**BEFORE THE HEARINGS PANEL
FOR THE QUEENSTOWN LAKES PROPOSED DISTRICT PLAN**

IN THE MATTER of Hearing Stream 14:
Wakatipu Basin
hearing and
transferred Stage 1
submissions related to
Arrowtown and Lake
Hayes

**REPLY OF BRIDGET MARY GILBERT
ON BEHALF OF QUEENSTOWN LAKES DISTRICT COUNCIL**

10 August 2018

Figure 1: Proposed Landscape Feature Setback line mapping amendment on the east side of Hunter Road, opposite 76 Hunter Road (Hamilton & Hayden land). Light green line depicts combined Precinct boundary and Landscape Feature Setback line. Light blue line depicts Precinct boundary only.

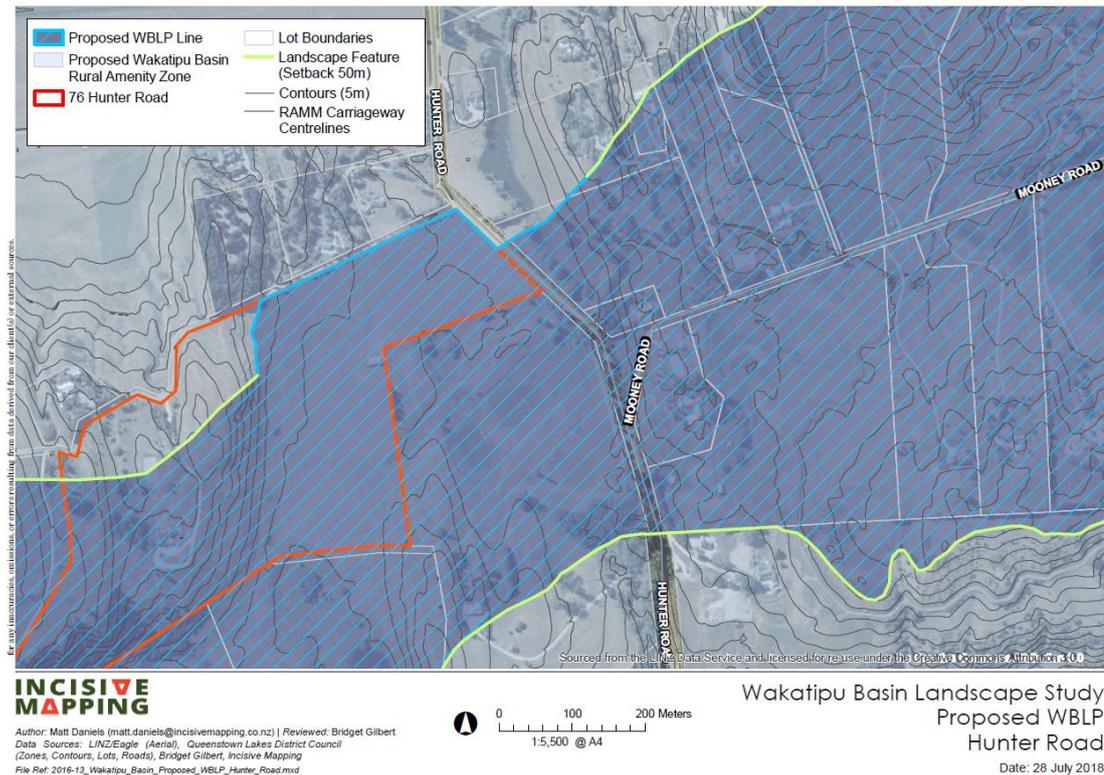
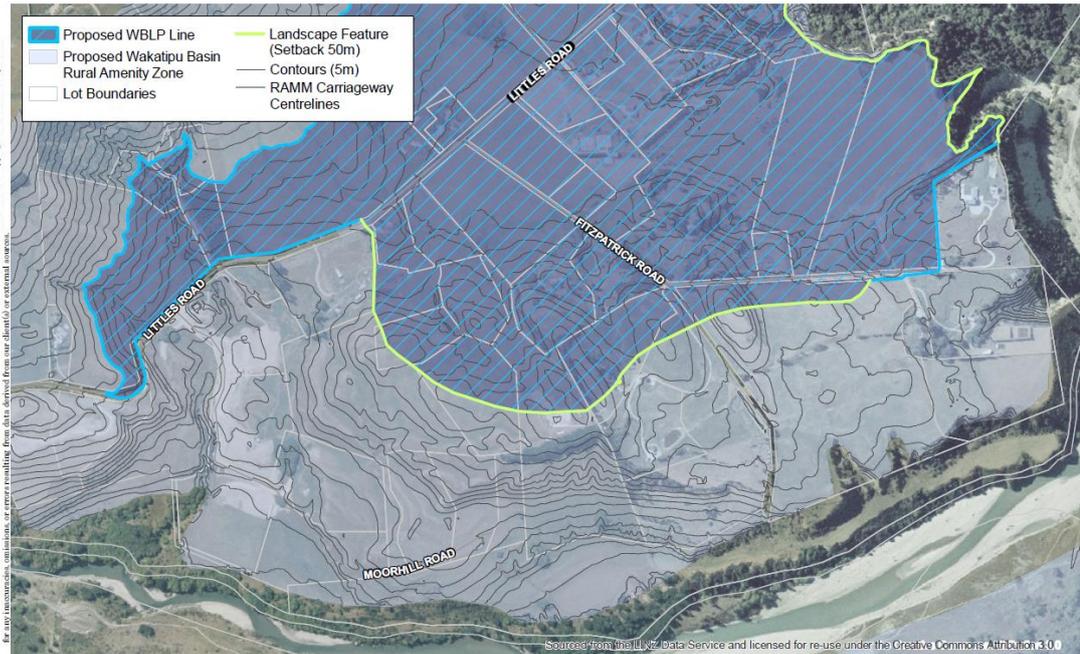
- 3.2** The Panel has asked me to consider whether the proposed change on the west side of Hunter Road (76 Hunter Road) might have implications for the configuration of the Precinct boundary and extent of the Landscape Feature Setback line on the east side of Hunter Road, effectively opposite the Hamilton & Hayden land.

- 3.3** My response to the Panel during the hearing was that it would not alter my recommendations with respect to the location of the Precinct boundary on the east side of the road (due to the considerably smaller area of low-lying land on the east side of the road in comparison to the west side); however, the Landscape Feature Setback line should be deleted from the low-lying portion of land on the east side of the Hunter Road, consistent with the approach adopted on the western side (i.e. the Hamilton & Hayden land).

- 3.4** The **Figure 1** mapping below illustrates the revised extent of the Landscape Feature Setback line on the east side of Hunter Road that I recommend. It should be noted that the Landscape Feature Setback line now applies to land on either side of Hunter Road that sits above the 435m contour, with the setback removed from the low-lying land flanking either side of the road where no such 'landscape feature'³ is evident. Such an approach is considered to be methodologically consistent.

Figure 2: Proposed (i.e. amended) extent of Precinct and Landscape Feature Setback line in the vicinity of LCU 2 Fitzpatrick Basin and LCU 3 Shotover River Terrace.

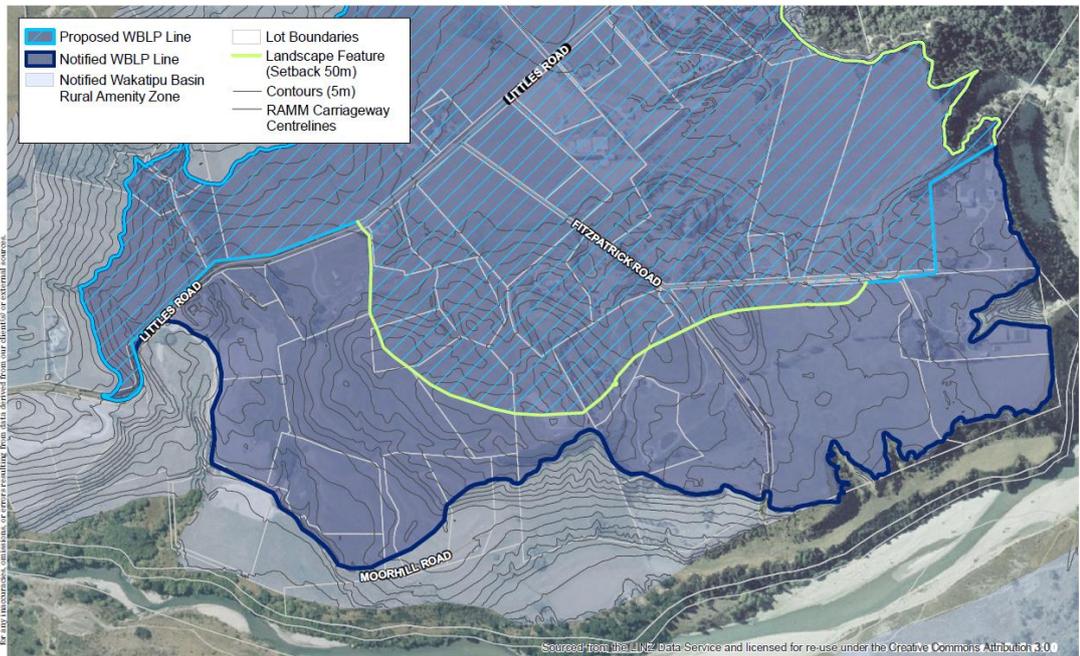
4.1 During the hearing, the Panel commented that it was their impression that the southern extent of LCU 2 Fitzpatrick Basin included land that ‘rolled over’ into the Shotover River terraces, which may be better identified as part of LCU 3 Shotover River Terrace. This has potential implications for both the LCU and Precinct mapping in this part of the Basin.

- 4.2** I have reviewed detailed Elevation, Contour and Slope Analysis mapping for the area in question, together with site photographs.
- 4.3** I confirm that the notified mapping of the southern margins of LCU 2 Fitzpatrick Basin (and therefore the Precinct) has inadvertently included land that drops away to the Shotover River.

- 4.4** The area in question reads as part of LCU 3 Shotover River Terrace and demonstrates a similar sensitivity to landscape change and capability to absorb additional development as outlined in the Schedule 24.8 description for LCU 3 Shotover River Terrace (i.e. a **low** absorption capability).

- 4.5** For these reasons, it is recommended that the alignment of the Precinct boundary in this portion of the Basin is amended to reflect the mapping in **Figures 2** and **3** below.

- 4.6** For completeness, the amended alignment of the Precinct boundary follows the crest of a ridgeline throughout the central portion of the revised mapping area.

- 4.7** In the absence of a clear geomorphological feature in the western sector, the boundary is aligned along the road corridor, to 'join up' the Precinct on the north and south side of Littles Road.

- 4.8** The eastern area also suffers from the absence of a clear geomorphological boundary and in this instance, the amended Precinct boundary follows property boundaries.

Figure 5: Proposed (i.e. amended) extent of Precinct and Landscape Feature Setback at the eastern end of LCU 6 Wharehuanui Hills.

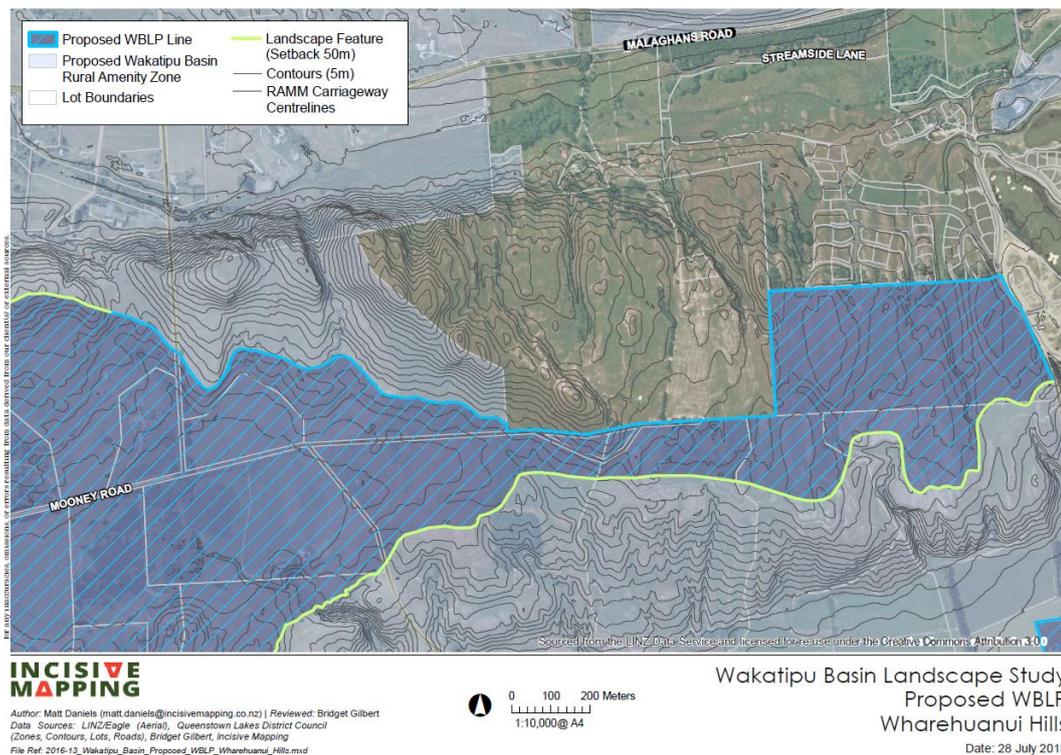
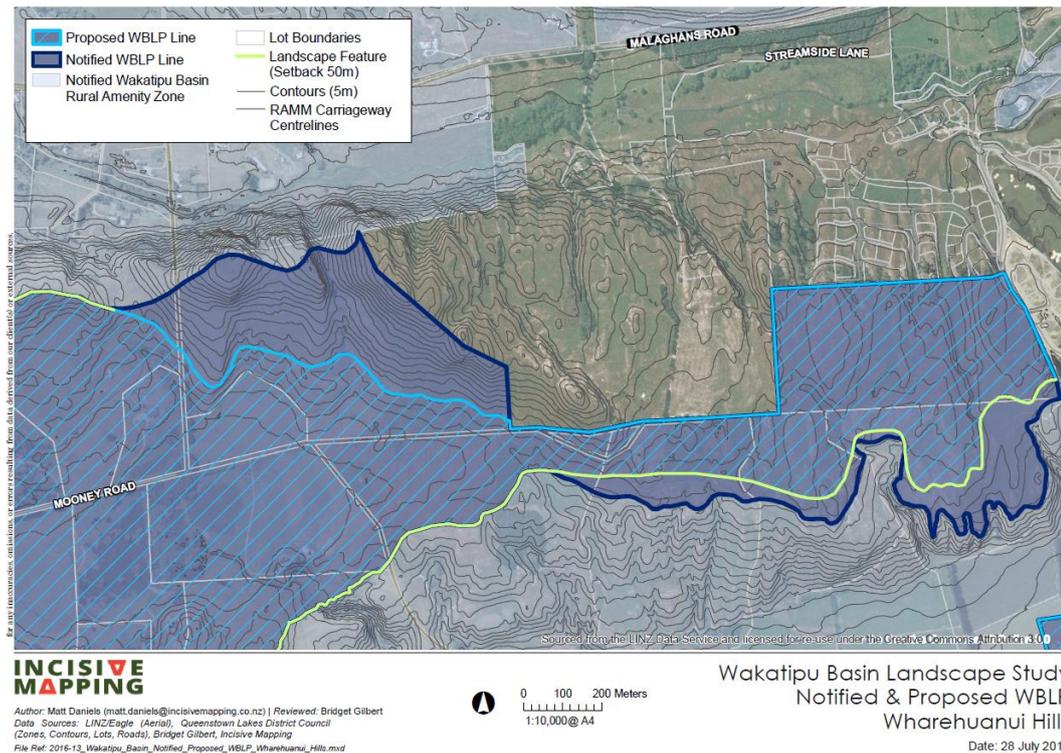
- 7.1** The Panel has queried the extent of the Precinct at the eastern end of LCU 6 Wharehuanui Hills, specifically in relation to:

- (a) the steep land separating the Mooney Road 'basin' from Millbrook; and
- (b) the elevated spur landforms in the vicinity of the X Ray Trust and Avenue Trust properties (2619) where the hill landforms effectively 'roll over' towards LCU 8 Speargrass Flats.

7.2 In considering effects in relation to Bendemeer, I have also reviewed the Precinct mapping in these locations, closely examining detailed Elevation, Contour and Slope Analysis mapping together with my site photographs.

7.3 On reflection, I consider that the Panel have raised valid concerns and the extent of the Precinct in these locations should be adjusted as depicted in **Figure 5** and **Figure 6** below.

7.4 With respect to the steep land separating the Mooney Road ‘basin’ from Millbrook, my amended Precinct line runs along the base of the steep landform, resulting in the steeply sloping land being identified as Amenity Zone.

- 7.6** In relation to the elevated spur landforms in the vicinity of the X Ray Trust and Avenue Trust properties (2619), where the hill landforms effectively 'roll over' towards LCU 8 Speargrass Flats, I recommend that the Precinct boundary (and Landscape Feature Setback) is 'pulled back' (i.e. moved northwards) to exclude the 'roll-over' portions of the hill landforms, as it is acknowledged that rural residential development in these locations has the potential to adversely impact on the low-lying Amenity Zone area nearby, despite the Landscape Feature Setback.
